Process Sheet

Customer : CU-DAR001 Dart Helicopters Services Drawing Name : BASKET BASE ASSEMBLY (350)
 Job Number : 37513C
 Estimate Number : 10189
 P.O. Number :
 This Issue : 2/20/2008 S.O. No. :
 Prsht Rev. : NC Part Number : D2221
 First Issue : 11 Type : LARGE FAB ASSY Drawing Number : D2221 U/R, D2235
 Previous Run : 37512C Drawing Revision : F/B1
 Written By :
 Checked & Approved By :
 Comment : Est Rev: 05.09.02 Added D3442-1 KJ/JLM

DESIGN BW	DRAWN BY PH	DART AEROSPACE LTD HAWKESBURY, ONTARIO, CANADA	
CHECKED <i>[Signature]</i>	APPROVED <i>[Signature]</i>	DRAWING NO. D2221	REV. F SHEET 1 OF 3
DATE 05.06.07		TITLE BASKET BASE ASSEMBLY (350)	SCALE NTS
C	95.11.21	SEPARATE BASKET AND LID	
D	96.06.21	CHANGE LATCH	
E	01.04.19	CHANGE HINGE	
F	05.06.07	ADD SHIM UNDER HINGES, ADD HOLES FOR SPLIT LID BASKETS

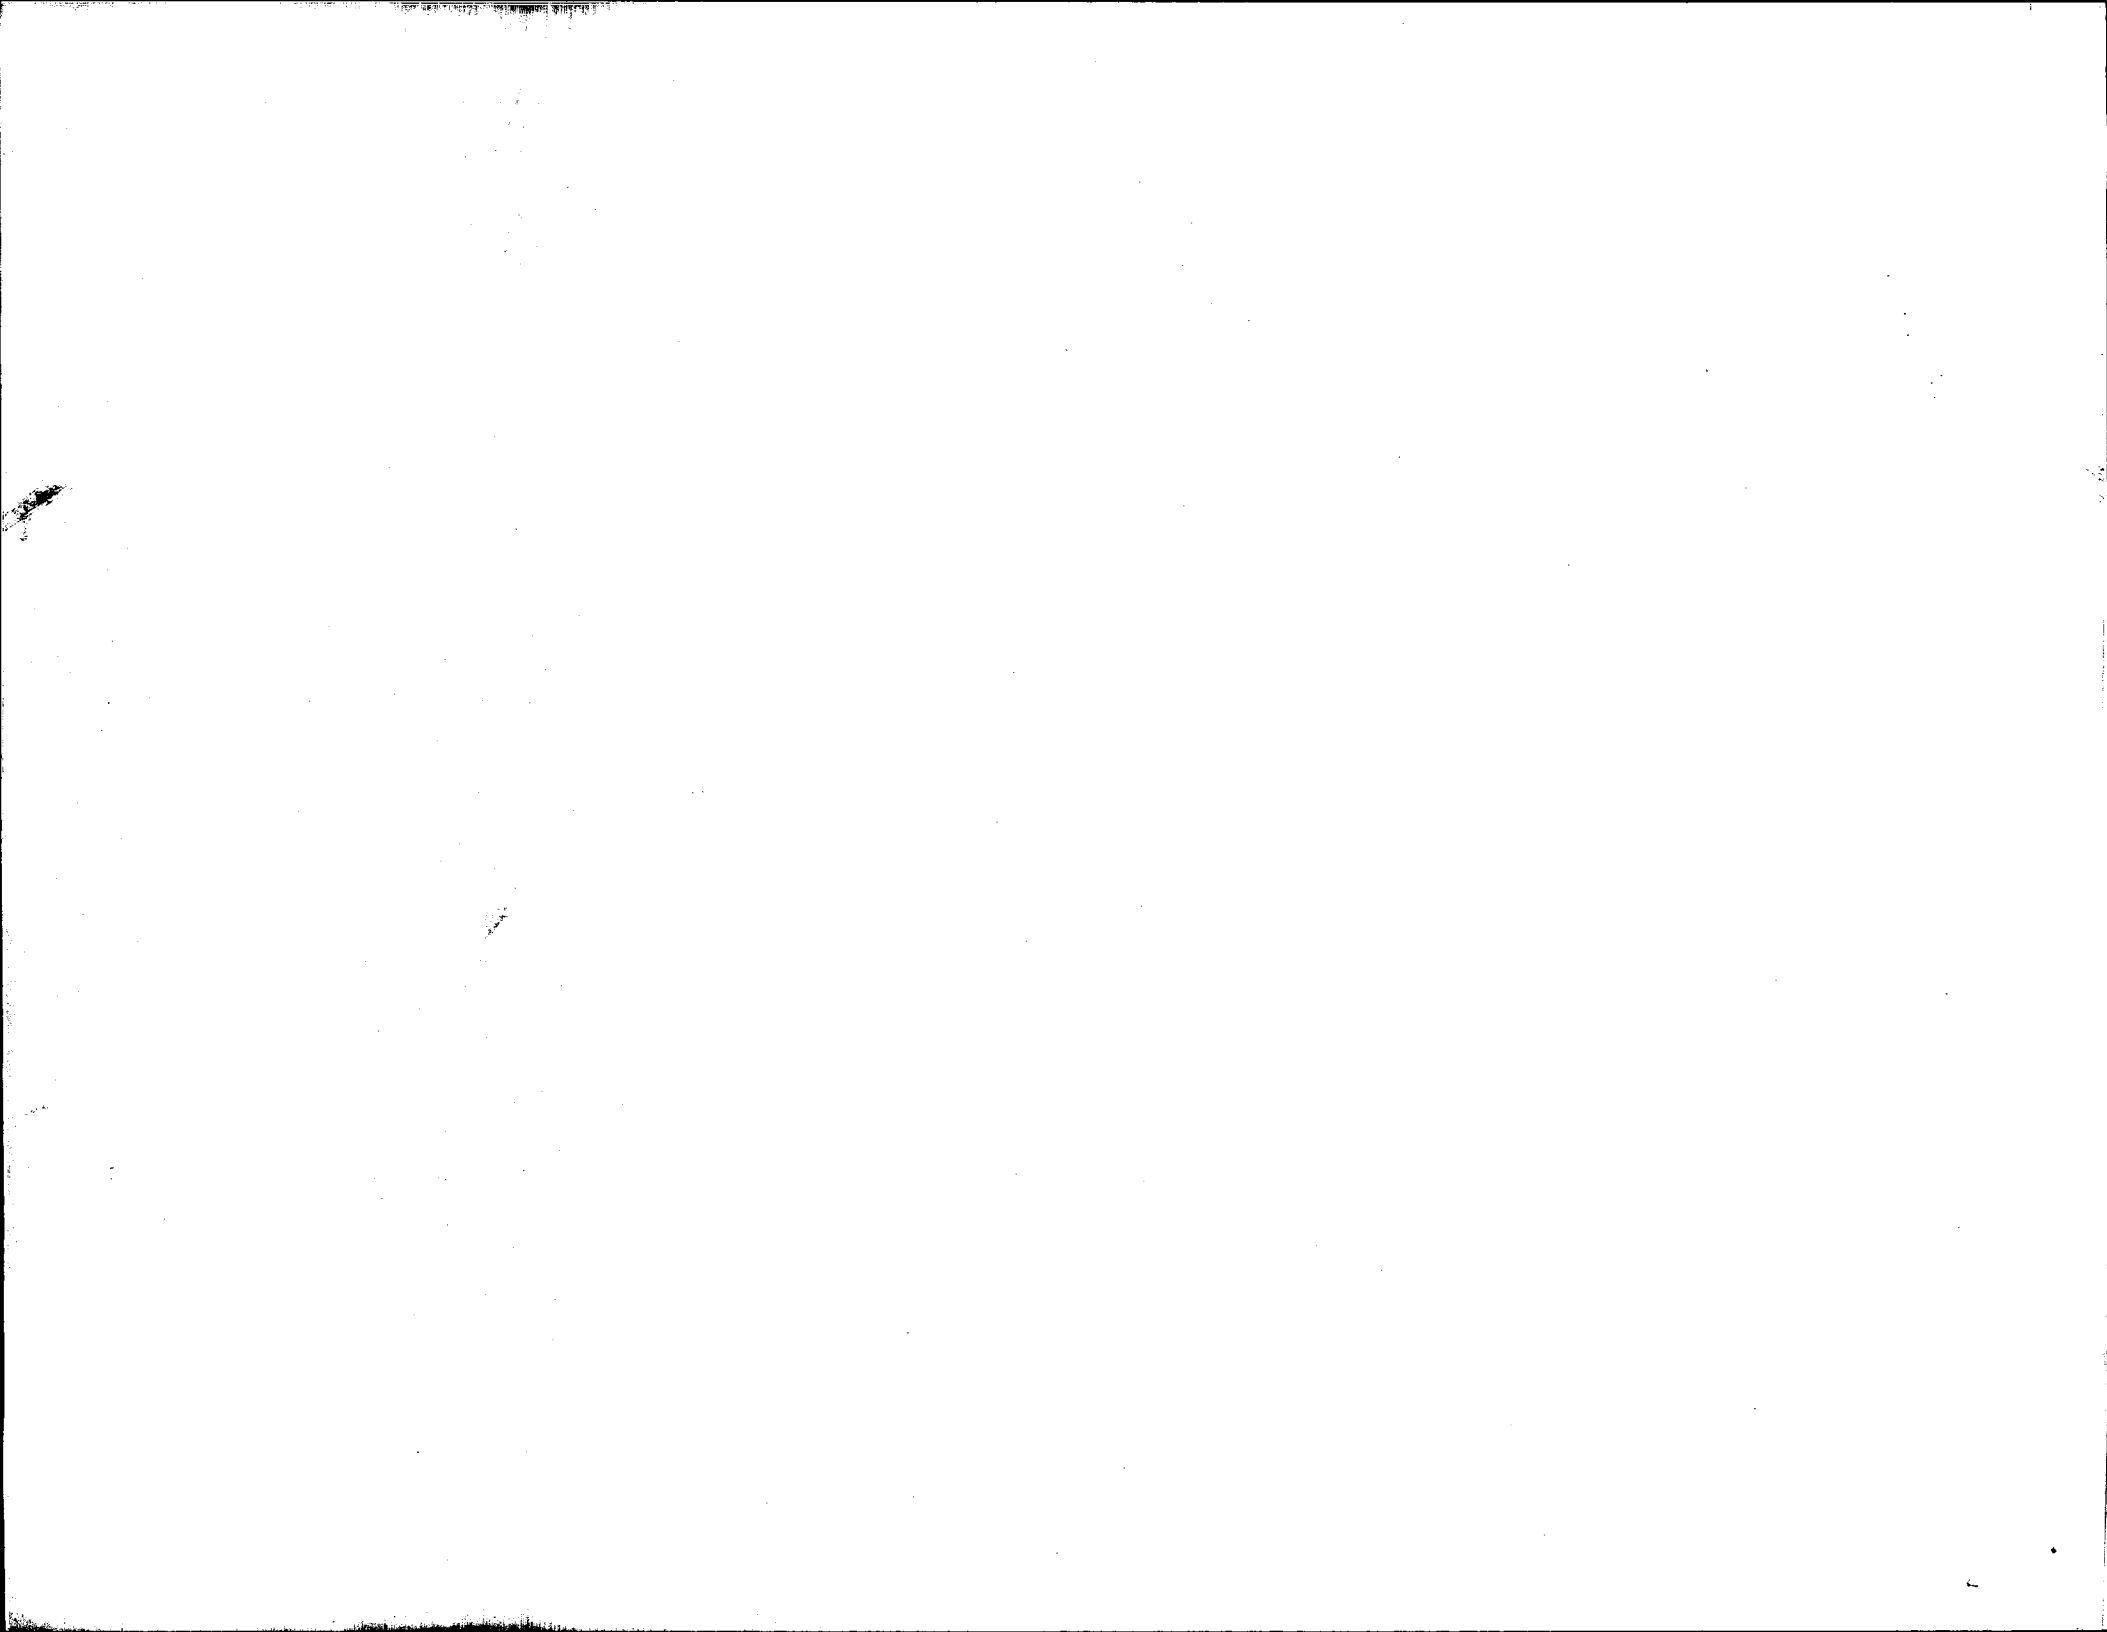
~~TUBING TO BE
CHANGED TO 0.065
WALL~~
RETURN TO
ENGINEERING
45 UNCONTROLLED COPY
SUBJECT TO AMENDMENT
WITHOUT NOTICE
WORK ORDER
NO. 375134

DESIGN	BW	DRAWN BY	PH	DART AEROSPACE LTD
CHECKED	<i>[Signature]</i>	APPROVED	<i>[Signature]</i>	HAWKESBURY, ONTARIO, CANADA
DATE	05.06.07	TITLE	D2221	REV. F
				SHEET 2 OF 3
				SCALE 1:20

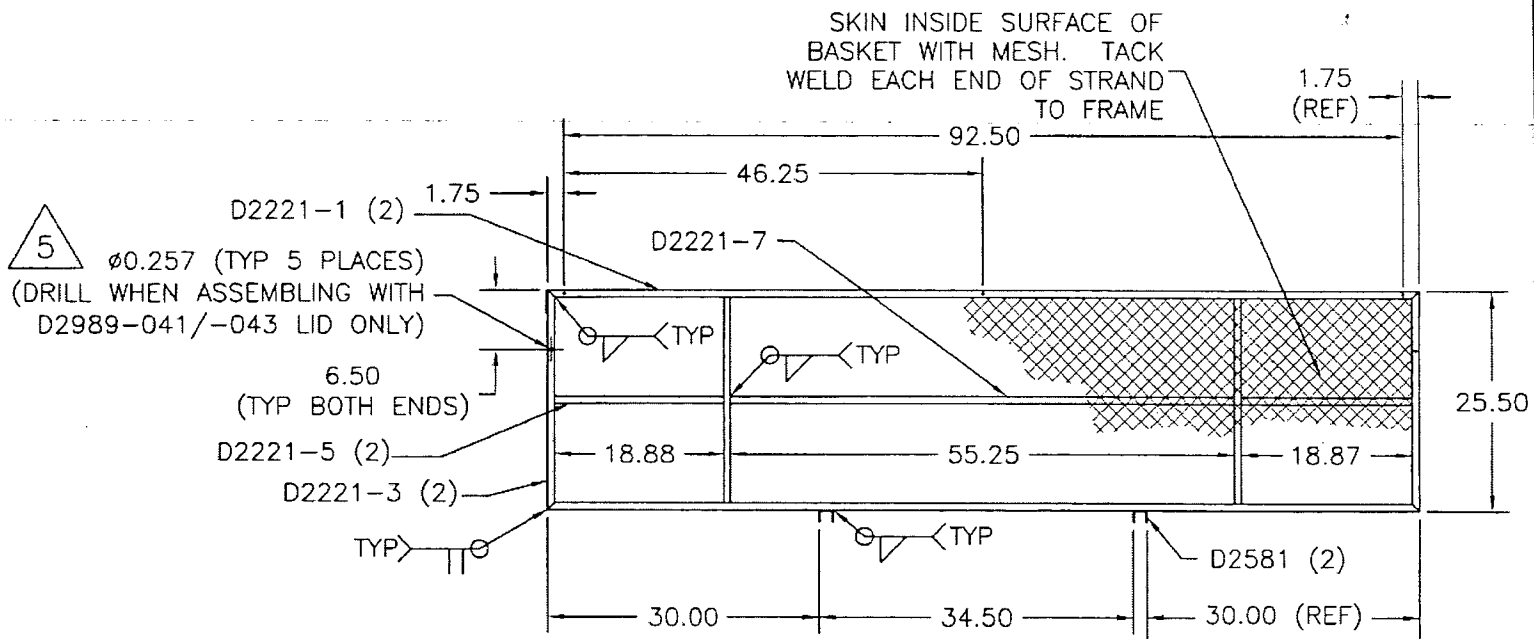
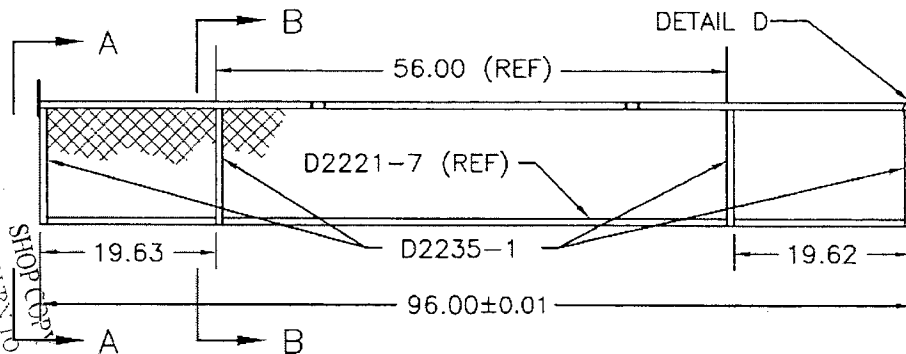
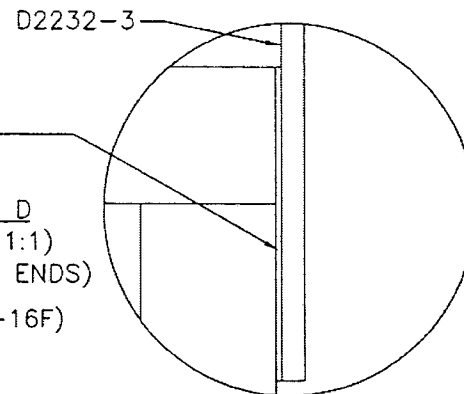
- 1) CUT LENGTH/SHAPE PER DIAGRAM AND PARTS LIST
- 2) MATERIAL: AISI 304/316 SS, 3/4 X 3/4 X 0.060 WALL SQUARE TUBING
(REF. DART SPEC M304TS0.750W.060) *0.055 04 03.02.21*
- 3) TOLERANCES ARE PER DART QSI 018 UNLESS OTHERWISE NOTED
- 4) ALL DIMENSIONS ARE IN INCHES
- 5) DRILL $\phi 0.257$ HOLES ONLY WHEN ASSEMBLING D2221 BASE WITH
D2989-041/-043 BASKET LID

UNDER REVIEW
08.08.09
TUBING TO BE
CHANGED TO 0.065
WALL
08.02.21

DESIGN BW	DRAWN BY PH	DART AEROSPACE LTD HAWKESBURY, ONTARIO, CANADA	
CHECKED [Signature]	APPROVED [Signature]	DRAWING NO. D2221	REV. F SHEET 3 OF 3
DATE 05.06.07	TITLE BASKET BASE ASSEMBLY (350)		SCALE 1:8

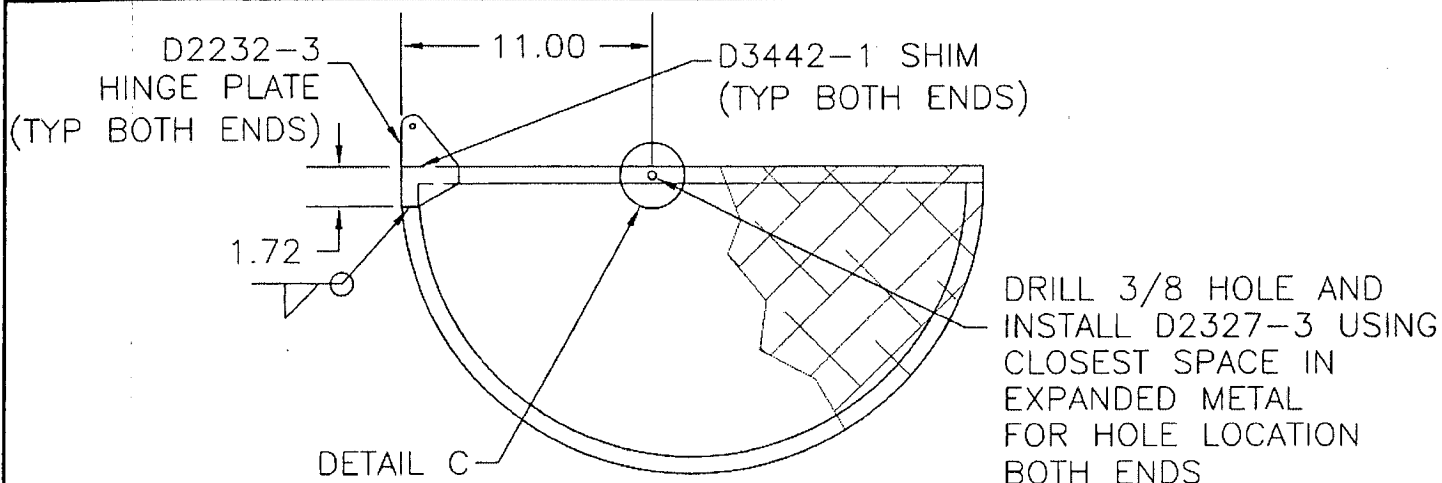
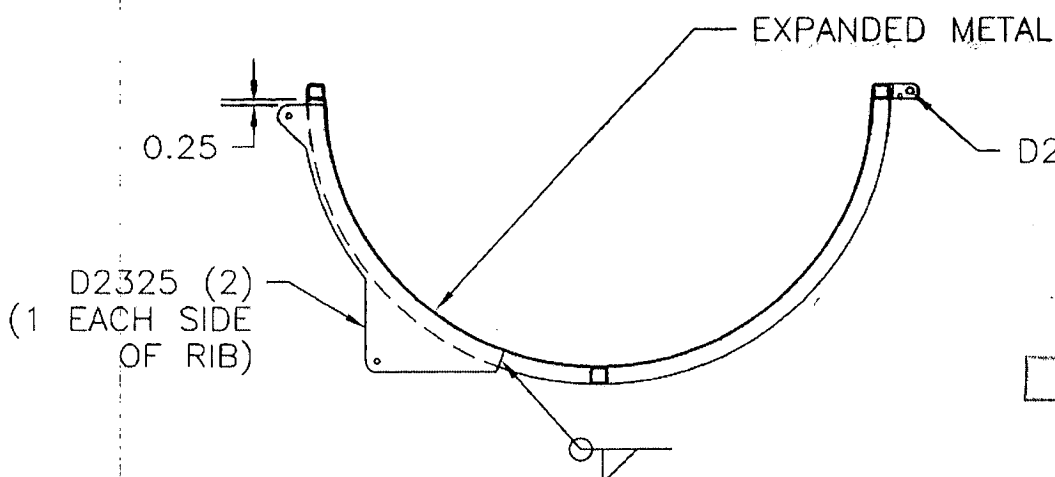
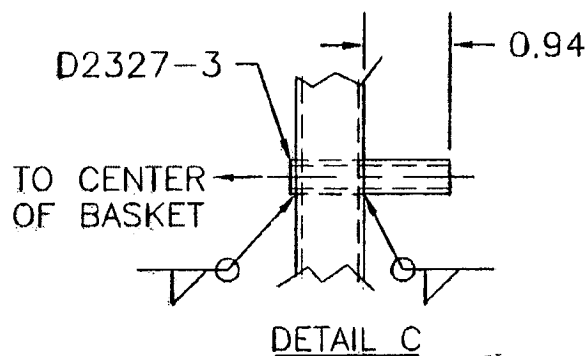
UNDER REVIEW
08.02.05 PH
TUBING TO BE
CHANGED TO 0.065
WALL
PH
08.02.05

DESIGN B WILLIAMS	DRAWN BY B WILLIAMS	DART AEROSPACE LTD VICTORIA INTERNATIONAL AIRPORT, CANADA	
CHECKED <i>BW</i>	APPROVED <i>BW</i>	DRAWING NO. D2235	REV. B SHEET 1 OF 1
DATE 94:12:16		TITLE BASKET RIBS	SCALE
BI	02.08.06 <i>U/A</i>	CAN BE MADE FROM D3166-1

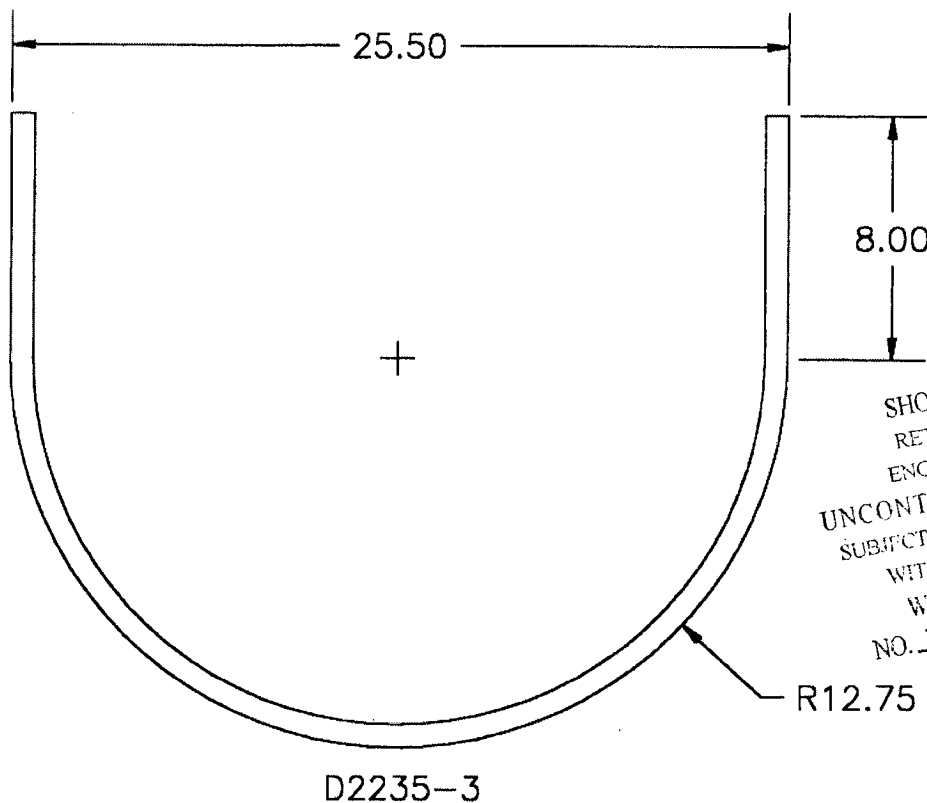
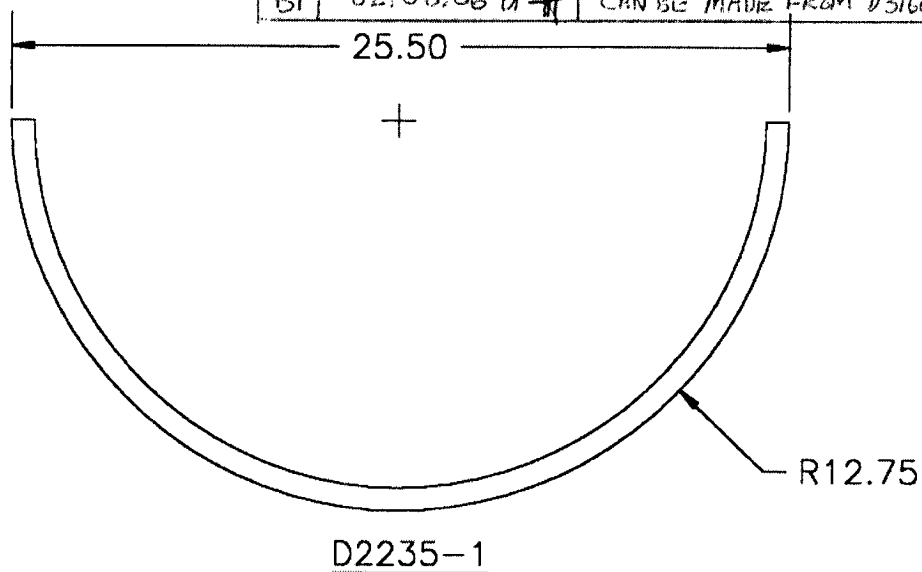
CAN BE MADE FROM D3166-1 
MATERIAL: 304/316 SS, 3/4 X 3/4 X 0.063 WALL SQR.
